FMC Idaho LLC, Pocatello, Idaho

**REMEDIAL DESIGN WORK PLAN
for the FMC OU**

December 2013

Appendix A	Remedial Design Quality Assurance and Quality Control
Appendix B	Example Design Drawings
Appendix C	Example Earthwork Specification
Appendix D	EPA and Agency Comments on the Remedial Design Work Plan (August 2013) and FMC Responses/Revisions

FMC
 REMEDIAL DESIGN WORK PLAN
 FIGURE 1-3
 REMEDIAL DESIGN
 PROJECT ORGANIZATION

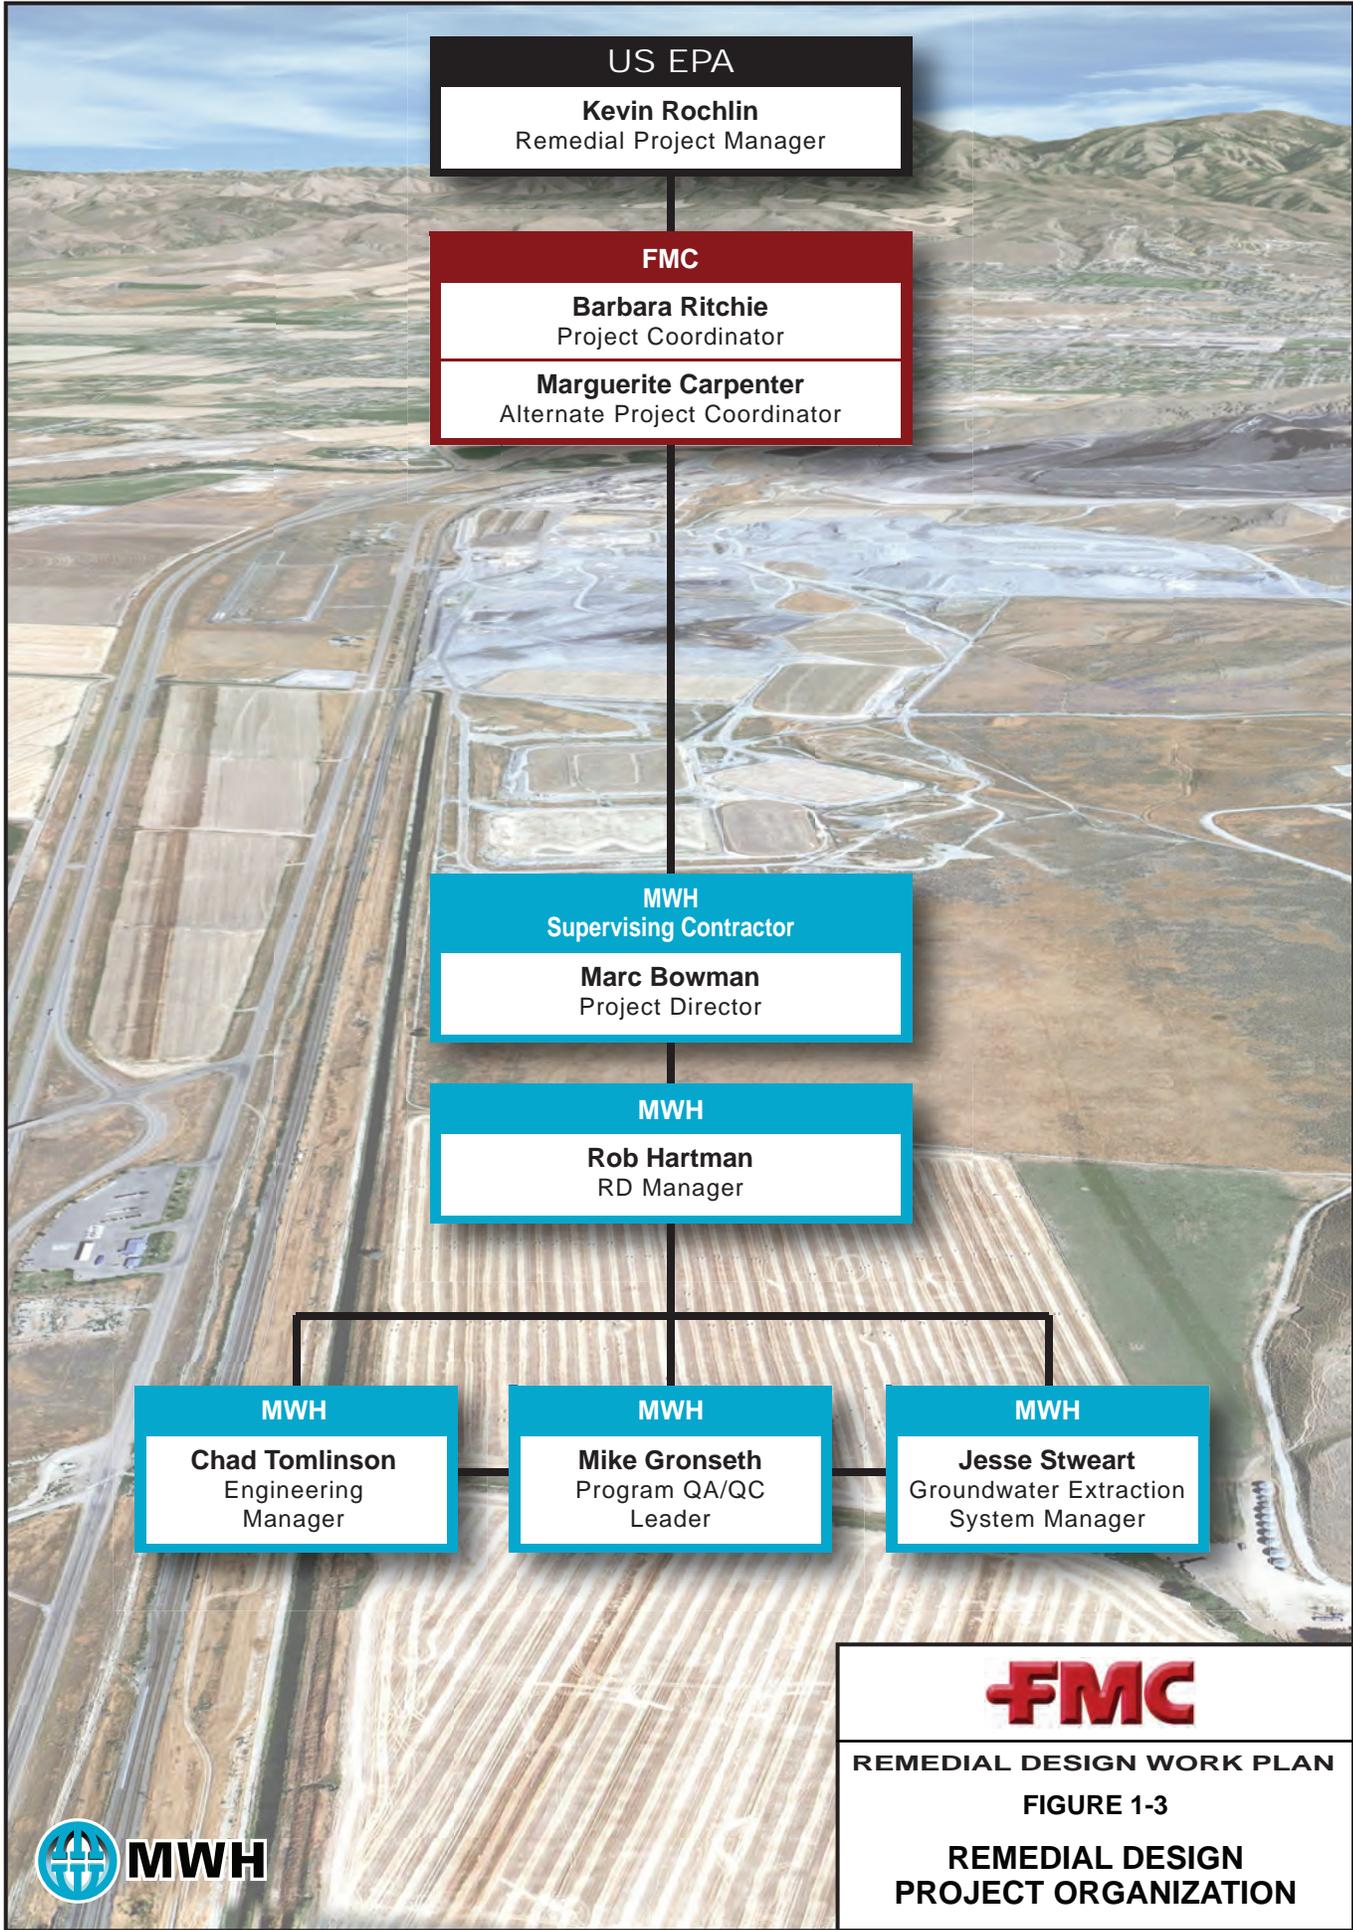
2. Figure 1.3

FMC Response: The organizational structure presented in Figure 1-3 is consistent with the UAO. No revision to the Work Plan is warranted.
